CALIFORNIA COASTAL COMMISSION

STAFF REPORT: REGULAR CALENDAR **W10b**

APPLICATION NO.: **4-97-071**

PROJECT LOCATION: 24612 Malibu Road, City of Malibu, Los Angeles County

EXHIBIT 8
4-97-071
REVISED BULKHEAD
LOCATION
(Per Special Condition #5)

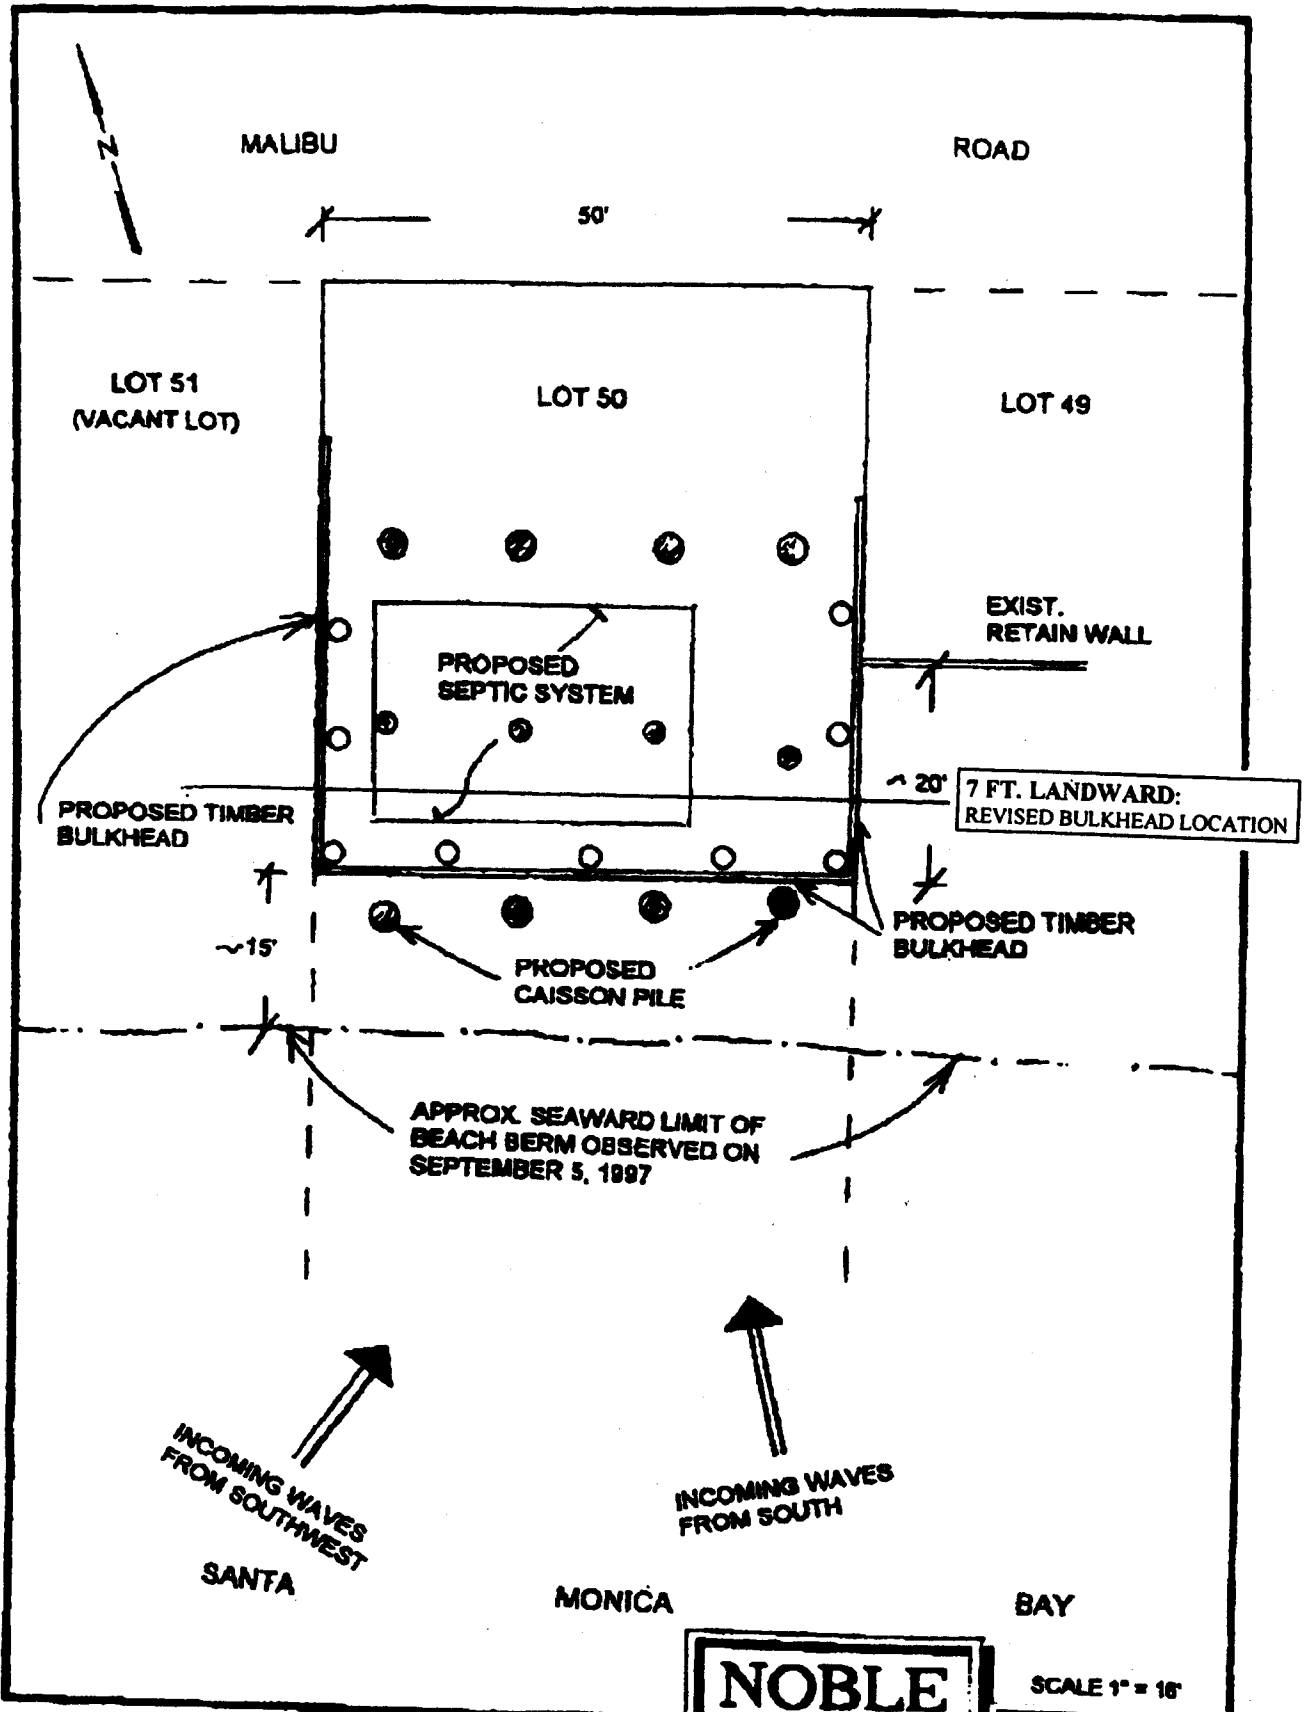
Prior to issuance of the permit, the applicant shall submit for the review and approval of the Executive Director revised plans which show the wooden bulkhead relocated at a minimum of seven (7) ft. landward from the current location on the site plans prepared by Goldman/Firth/Boccatto Architects dated September 9, 1996 and revised March 3, 1997. This shall be accomplished by redesigning either the size, location or type of septic system and shall involve, if necessary, the removal or the reduction of the 580 sq. ft. basement/storage area and/or the reduction in the number of bedrooms. The applicant shall submit evidence, for the review and approval of the Executive Director that the revised plans have been reviewed and approved by the City of Malibu Health Department.

For the reasons previously given, special condition #5 requires the applicant to revise the location of the proposed bulkhead landward by 7 ft. Given that the proposed seawall, as conditioned, will be sited as far landward as is possible, the project's ability to act as an artificial headland will be lessened. Additionally, the setback of the structure will serve to minimize the interruption of the onshore and longshore processes because the seawall will be 7 ft. closer to the base of the coastal bluff. Additionally, the required lateral access will serve to mitigate the loss of sandy beach that may be impounded by the structure. Therefore, for all the reasons explained above, the Commission finds that, as conditioned, the proposed project will mitigate the adverse impacts on shoreline sand supply to the greatest extent feasible and is consistent with the applicable policies of the Coastal Act referenced above.
